## Product Change Notification / KSRA-13AKNI696

CCB 4440 Final Notice: Qualification of MMT as an additional assembly site for selected MTCH112, MTCH810 and PIC12xxxx device families available in 8L DFN (3x3x0.9mm) package.

**CCB 4440**  
**Pre and Post Change Summary**  
**Lead Frame Comparison**  
**PCN#: KSRA-13AKNI696**

# Lead frame comparison

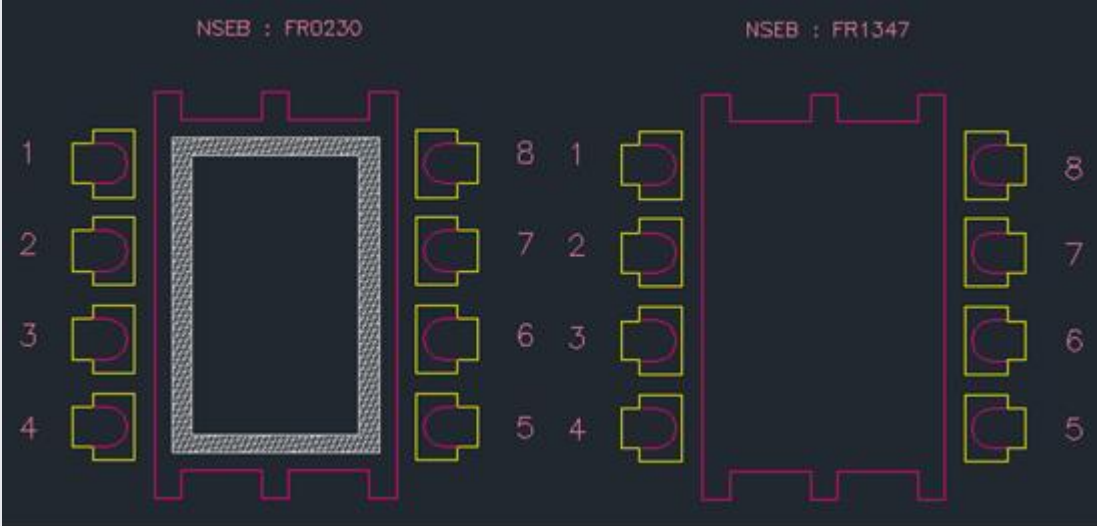
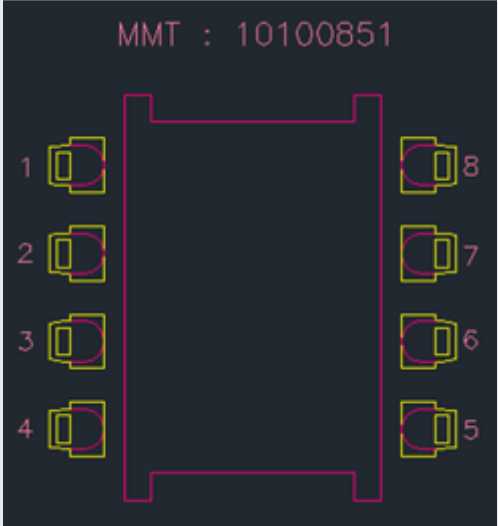
Pre change	Post Change				
NSEB	MMT				
 <p>The diagram shows two lead frame layouts for NSEB. The left layout is labeled 'NSEB : FR0230' and features a central square cavity with a textured pattern. The right layout is labeled 'NSEB : FR1347' and is a solid rectangular frame. Both layouts have eight leads, numbered 1 through 8, arranged in two columns of four on each side.</p>	 <p>The diagram shows a lead frame layout for MMT, labeled 'MMT : 10100851'. It is a solid rectangular frame with eight leads, numbered 1 through 8, arranged in two columns of four on each side.</p>				
<table><tr><td>Lead frame lead-lock</td><td>No</td></tr></table>	Lead frame lead-lock	No	<table><tr><td>Lead frame lead-lock</td><td>Yes</td></tr></table>	Lead frame lead-lock	Yes
Lead frame lead-lock	No				
Lead frame lead-lock	Yes
